SUPPLEMENTAL GEOTECHNICAL LETTER

Subject: EIR Update, Dana Point Harbor Hotels, City of Dana Point, California

RESPONSE TO CITY OF DANA POINT GEOTECHNICAL REPORT REVIEW (2019) AND RESPONSE TO CITY OF DANA POINT SECOND ENGINEERING REVIEW (2020)

Subject: Response to City of Dana Point Geotechnical Report Review Comments – dated November 14, 2019, Preliminary Geotechnical Investigation, Dana Point Harbor Revitalization, Hotel Component

ct No.	Geotechnical Sections	OTECHNICAL LEGEND RAMMED AGGREGRATE PIERS (30 FEET WIDE) SOIL CEMENT COLUMNS (10 FEET WIDE)	400 440 514	AGROUND PARKING CTURE EXTENSION TC -40	₩ TD 2	40	
Plate 3	ns	Ē		ō		0	0

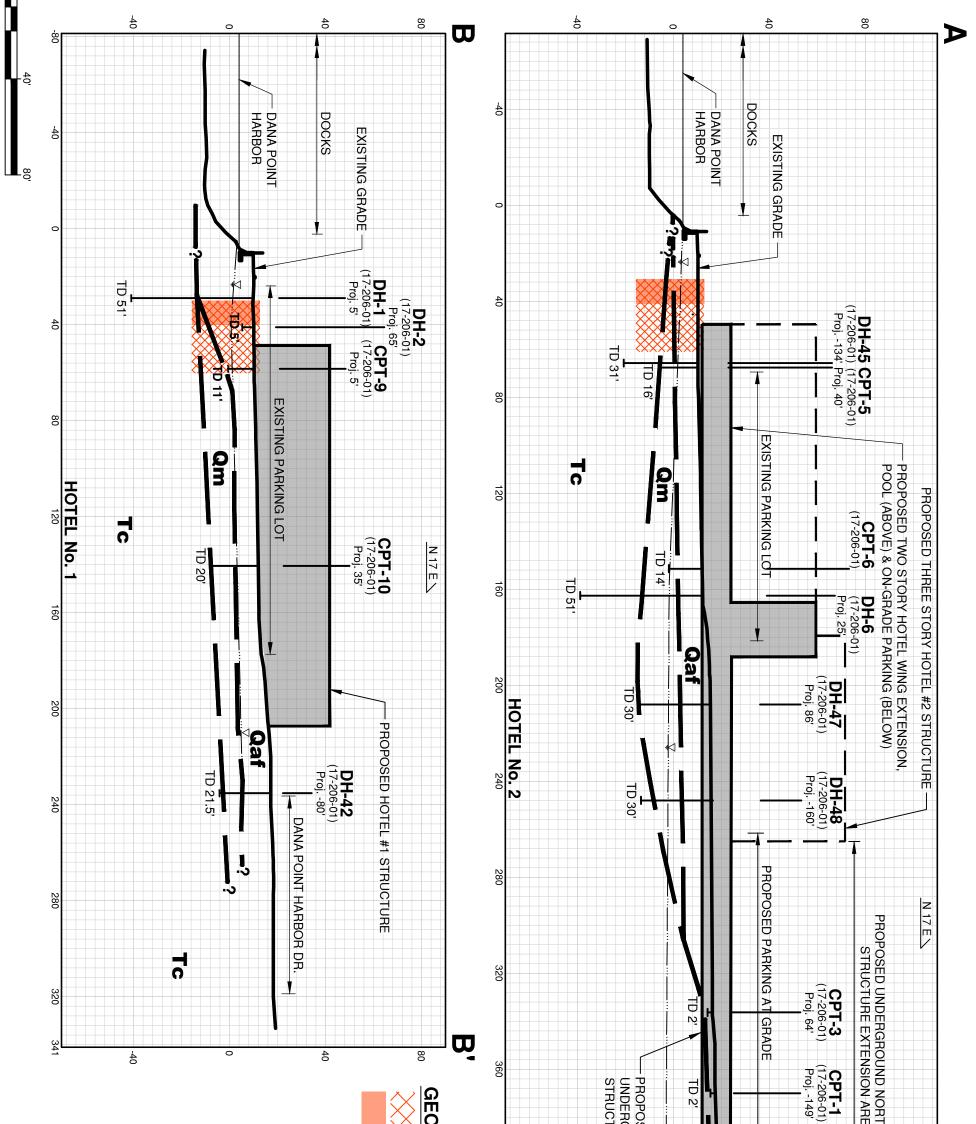
for temporary excavations are as follows: structure. As stated in our report regarding temporary excavations: "Our recommendations excavation limits for the construction of the Dana House Hotel underground parking Sections. Please refer to both Section A-A' and C-C' for notation of the locations of temporary going through the lower level of the Dana House Hotel, to the attached Plate 3 - Geotechnical GMU Response: To aid in the response to this item, we have added a cross-section C-C',

shown on the attached Plate 3 – Geotechnical Sections. The differential settlement is estimated attached Plate 2 – Geotechnical Map and on the corresponding geologic cross-section A-A' to the superstructure. The general location of the proposed joint is shown on the revised and suggested as an additional "belt and suspenders" design item to minimize structural cracking the design to span the cut/fill transition." To explicate upon this further, the joint was proposed building be supported on a mat foundation with a structural joint incorporated into settlement and cut/fill transition anticipated below the building pad, we recommend that the GMU Response: In our submitted geotechnical report dated September 10, 2019, regarding to be 1 inch over approximately 90 feet with respect to the bedrock/fill transition. the Dana House Hotel building, we stated at the bottom of page 21: "Due to the seismic

With regard to set-back of DSM columns from the seawall, the DSM columns will need to be 20 feet away from the seawall (see Plates 2 & 3). With regard to the set-back of the DSM columns from existing structures, it is anticipated that all significant structures in the vicinity of the planned DSM columns will be demolished prior to construction. Consequently, given the circular configuration of the piles as well as the anticipated demolition, set-back from existing structures is not anticipated to be as significant design constraint. It should be further noted that it is unknown at this time, what the exact construction timing is of the DSM columns which are needed to minimize lateral spreading. Set-back will be re-evaluated once the
